TPB Ref.: A/YL-TT/651

Proposed Temporary Warehouse for Storage of Construction Materials for a Period of 3 Years & Filling of Land at Lot 2230 RP (Part) in D.D. 118 & Adjoining Government Land, Yuen Long, New Territories

Our response to the comments of the CE/MN, DSD is found below:

Photo 1

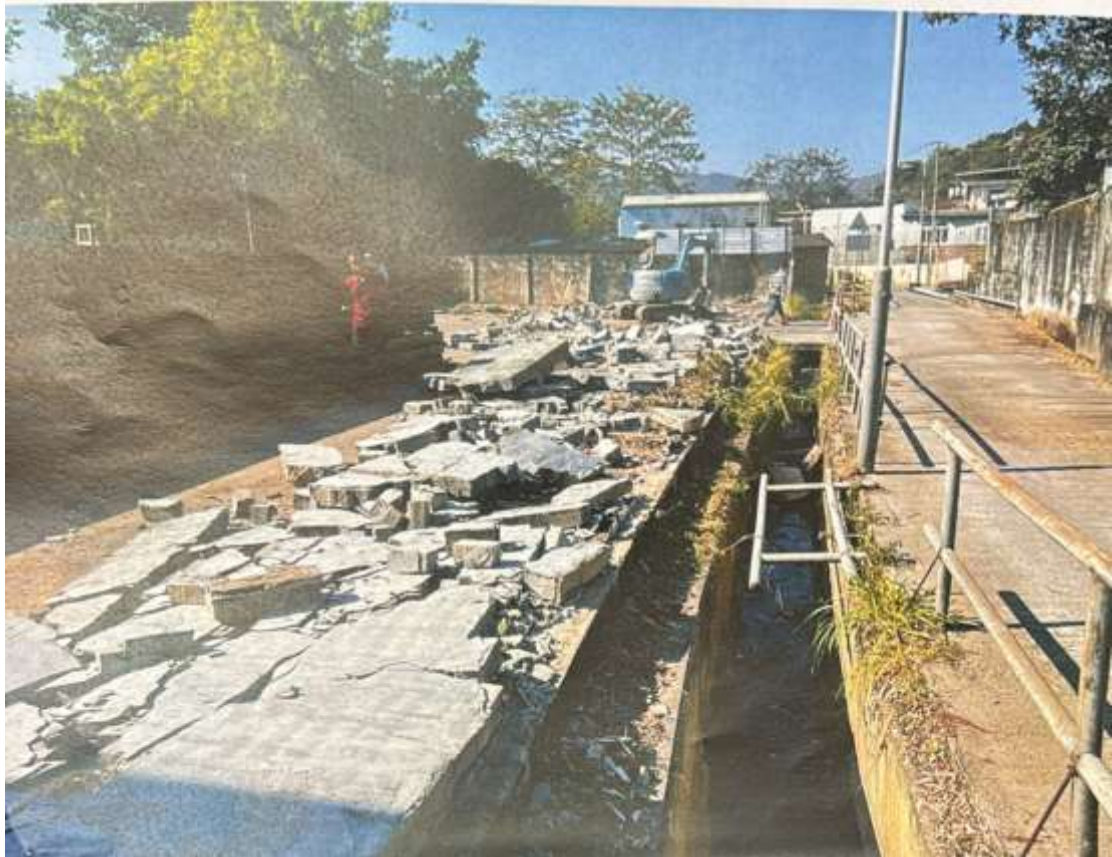
- (iv) Photo record is shown in the following. The photo viewpoint is shown on the updated drainage plan.
- (v) The cover level and invert level of the proposed U-channel, catchpit and sand trap are shown on the updated drainage plan.

Photo showing the existing discharge path

Figure 4

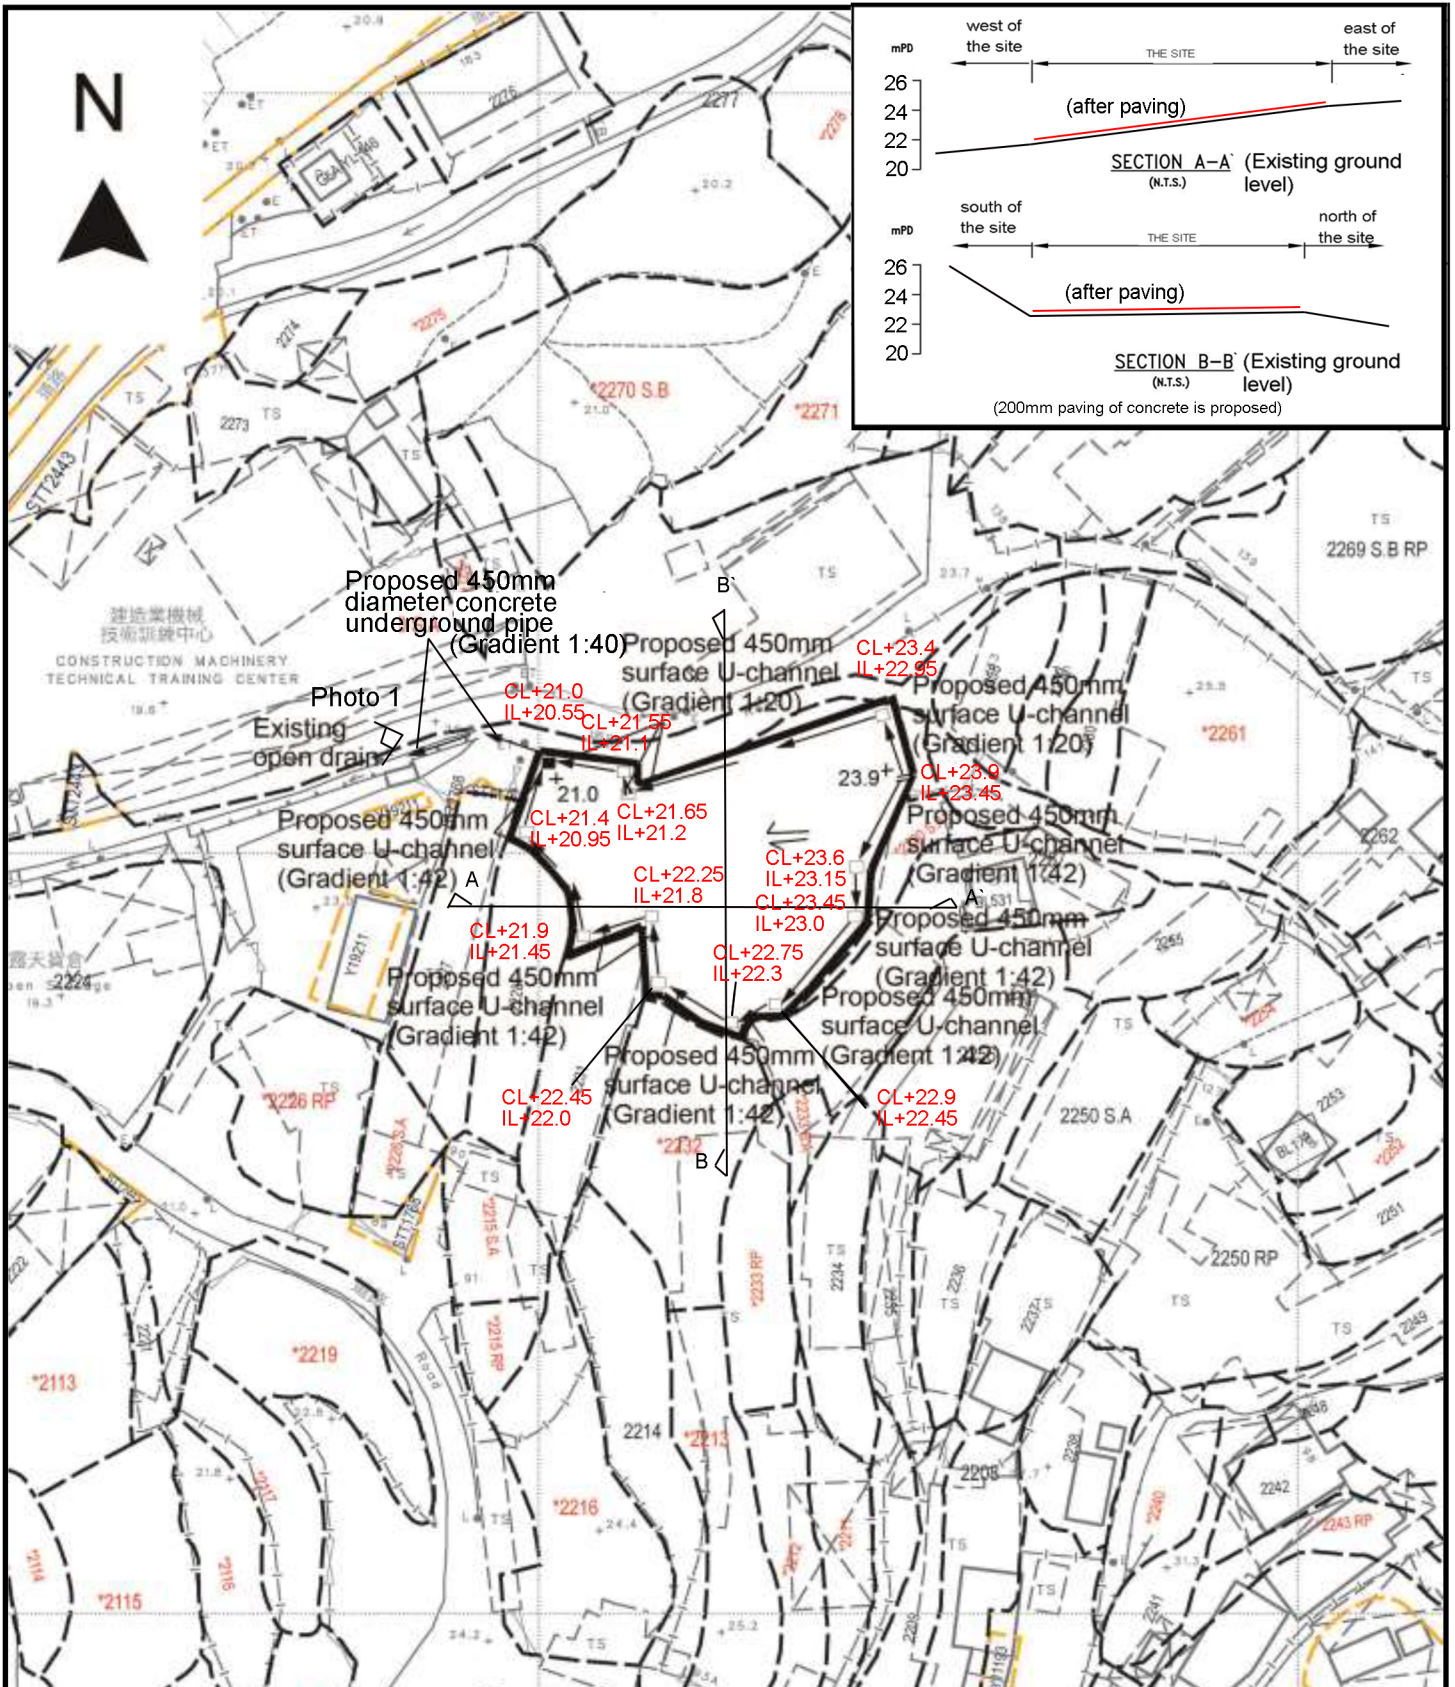
- (i) Noted. The ground to the south of the application site is generally higher so that an external catchment is included in the updated calculation below.

- (vi) Cross section showing the existing and proposed ground levels of the captioned site with respect to the adjacent areas is shown on the updated drainage plan.
- (vii) Standard details of the sectional details of the proposed U-channel, catchpit and sand trap are given.
- (viii) 100mm opening would be given at the toe of the site hoarding.
- (ix) \The development would neither obstruct overland flow nor adversely affect existing natural streams, village drains, ditches and adjacent areas, etc.

- 1.3.1 Subject to the calculations in 1.2 above, it is determined that proposed 450mm concrete surface U-channel along the site periphery is adequate to intercept storm water passing through and generated at the application site (**Figure 4**).

- 1.3.2 The collected stormwater will then be discharged directly to the open drain to the immediate west of the application site as shown in **Figure 4**.

Figure 17

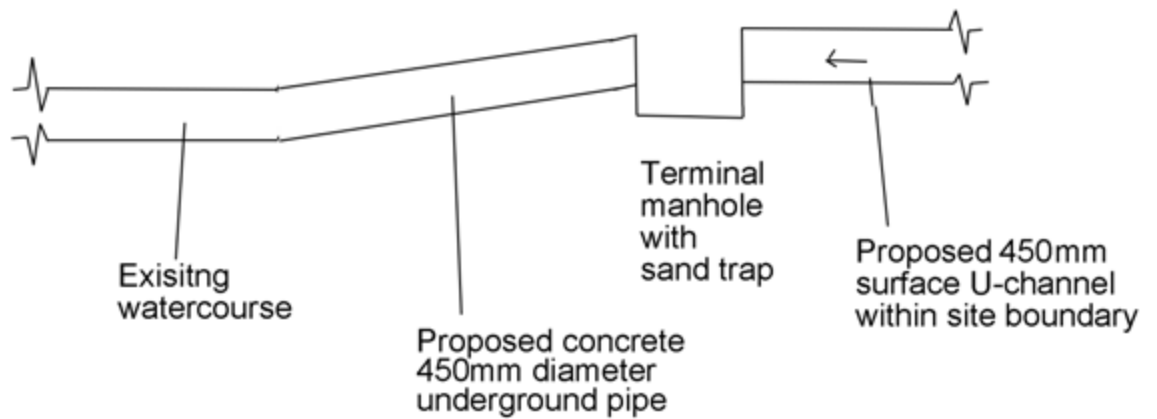
- (ii) The type, size and gradient of the proposed drain connecting from the last catchpit to the existing drain is shown on the updated drainage plan. The connection details to the existing open drain is shown in attached Figure 17.
